# AGENDA

## NORTHERN BEACHES LOCAL PLANNING PANEL

**WEDNESDAY 15 NOVEMBER 2023**

4.1	DA2023/0299 - 29 Reddall Street, Manly - Demolition works, subdivision of three lots into five and construction of five new dwelling houses with swimming pools, associated landscaping and parking.....	5

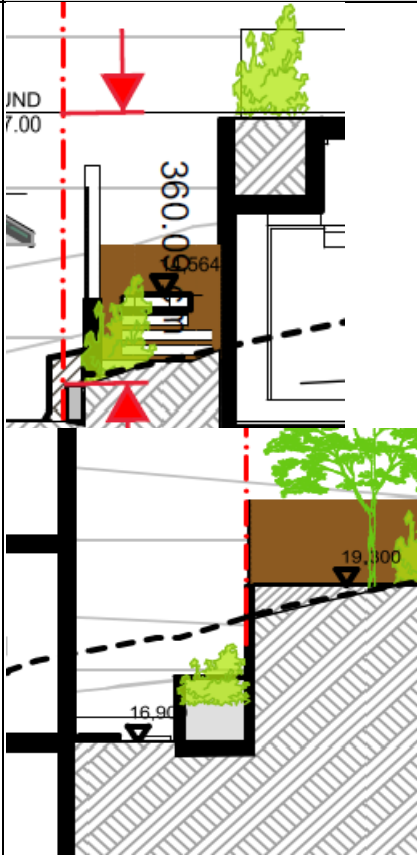
Internal Referral Body	Comments
	 <p>2. Similar applies to No 9 College St. (Extract from Landscape Plans and Sections 9 College Street below)</p>

Internal Referral Body	Comments
	 <p>3. In general terms, the rear retaining walls are quite high (&gt;3 metres height). Built form will be predominant and subsequently cannot rely on soft landscape for amelioration. (Section extract below).</p>

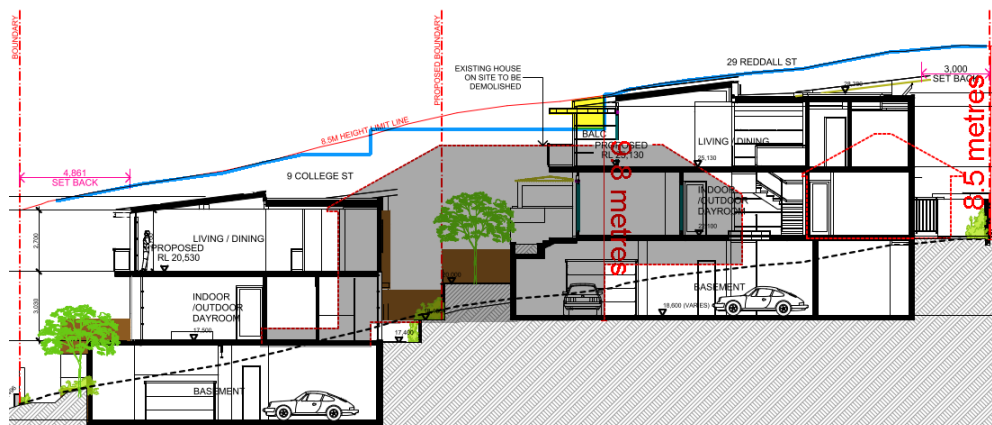
The submitted elevation and section plans do not demonstrate existing ground levels (including where disturbed by development) and extrapolated natural ground levels. Further, the proposed development is not supported by a written request to vary the development standard contained within Clause 4.3 of the MLEP, in accordance with Clause 4.6 Exceptions to Development Standards of the MLEP. It is anticipated that the proposed development will result in view loss attributable to the non-compliant height of buildings, in contravention of objective (c)(ii) of Clause 4.3 of MLEP, which provides:

(i) views to nearby residential development from public spaces (including the harbour and foreshores)

This is included as a reason for refusal.

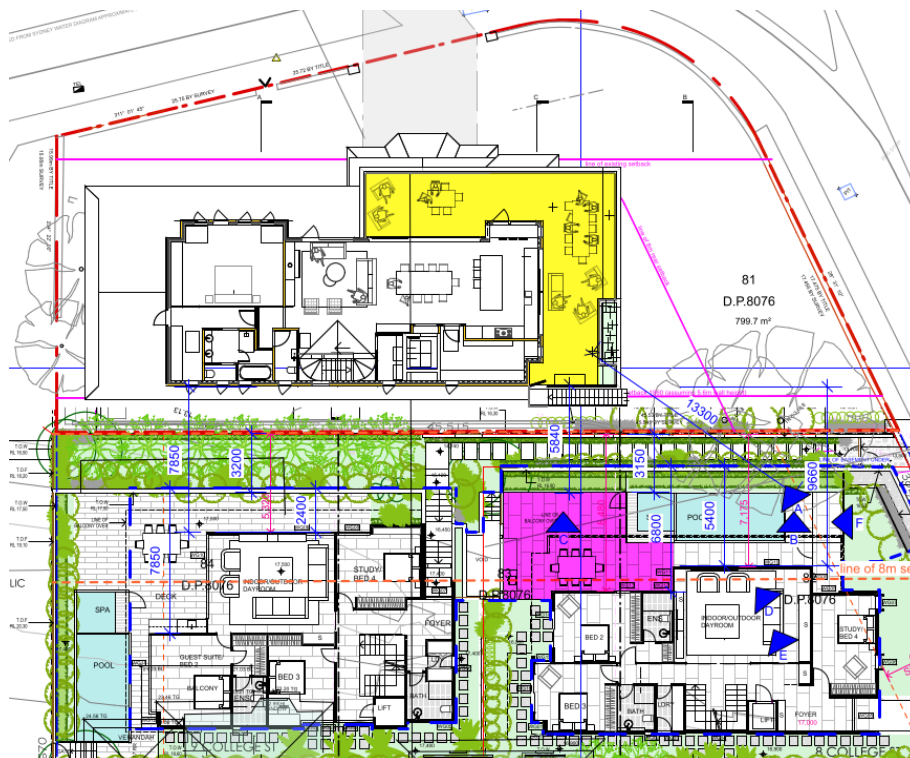
With respect to No. 95 Bower Street to the north-east of the subject site:

The owners of No. 95 Bower Street raised concern about the new dwelling on proposed Lot 4 overlooking of the private open space areas on their property (which include decks at the ground and first floors, and a landscaped lawn area). The private open space areas of No. 95 Bower Street are located to the south-east of No. 95 Bower Street.

The dwelling of concern (on proposed Lot 4) is designed such that it does not result in an unreasonable visual privacy outcome to No. 95 Bower, as follows.

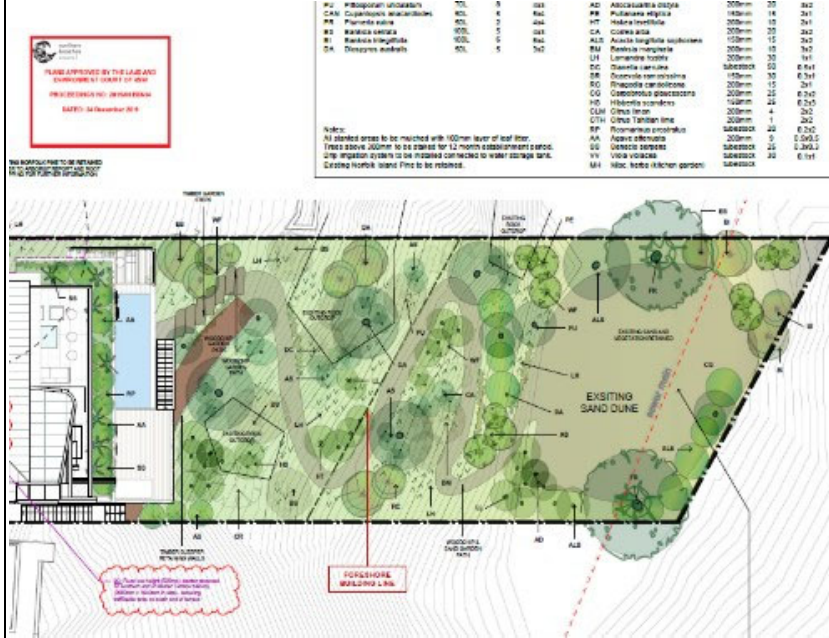
The submissions raised concerns that the proposed deck landing is located on an area of natural dune-scape providing sand and grasses across the beach front properties. This low lying area currently forms a catchment bowl for stormwater runoff and sediment and the submission is concerned that building in this area may impede the existing water course. The submission raises concerns regarding the increased built area due to the deck landing which will continue to diminish the landscape amenity and foreshore outlook.

The applicant has provided amended plans reducing the extent of the deck landing and providing increased landscaping. The applicant has also provided a Clause 4.6 written request to vary Clause 7.8 Limited Development on Foreshore Area of the PLEP 2014. A detailed assessment is provided under Clause 4.6 of this report. Furthermore, a detailed assessment on landscaping is provided under D12.10 Landscaped Area of this report.

- (a) *that compliance with the development standard is unreasonable or unnecessary in the circumstances of the case, and*
- (b) *that there are sufficient environmental planning grounds to justify contravening the development*

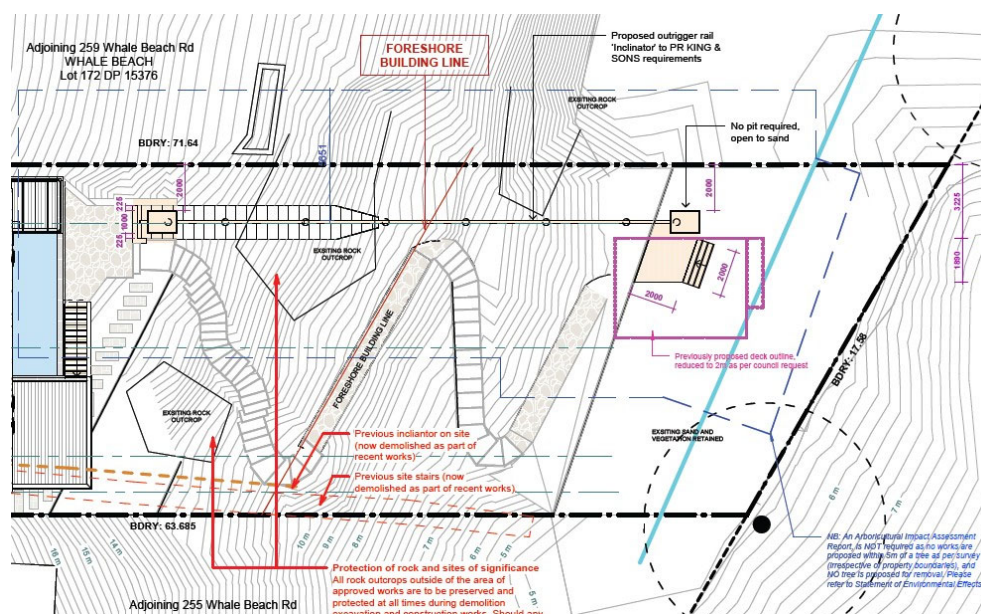
Development standard:	Clause 7.8 Limited Development on Foreshore Area
Requirement:	Foreshore Building Line (FBL)
Proposed:	10.4m extension into Foreshore Area
Percentage variation to requirement:	Non-numerical development standard

The environmental planning grounds advanced by the applicant within the Cause 4.6 written request are not sufficient to justify the variation. While the rear of the site is steep and the inclinator would improve the scope of access, the site already benefits from an existing formed pathway to the foreshore area and rear of the site (Figure 2). As such, the existing pathway appropriately provides access to the lower portion of the site allowing transport of items and maintenance, in to what is otherwise a vegetated area with little useable area. Clause 7.8 permits waterway access stairs within the foreshore area to serve the purpose of providing reasonable access to the foreshore, whereby an inclinator is not considered necessary for that purpose. Additionally, the site obtains vehicular access from Whale Beach Road and an inclinator is not fundamental to provide access to the site in any way. The rear of the site adjoins Whale Beach, which in itself is directly accessible from an car park. If the inclinators purpose is in part to access Whale Beach, then such access is available in a way that does
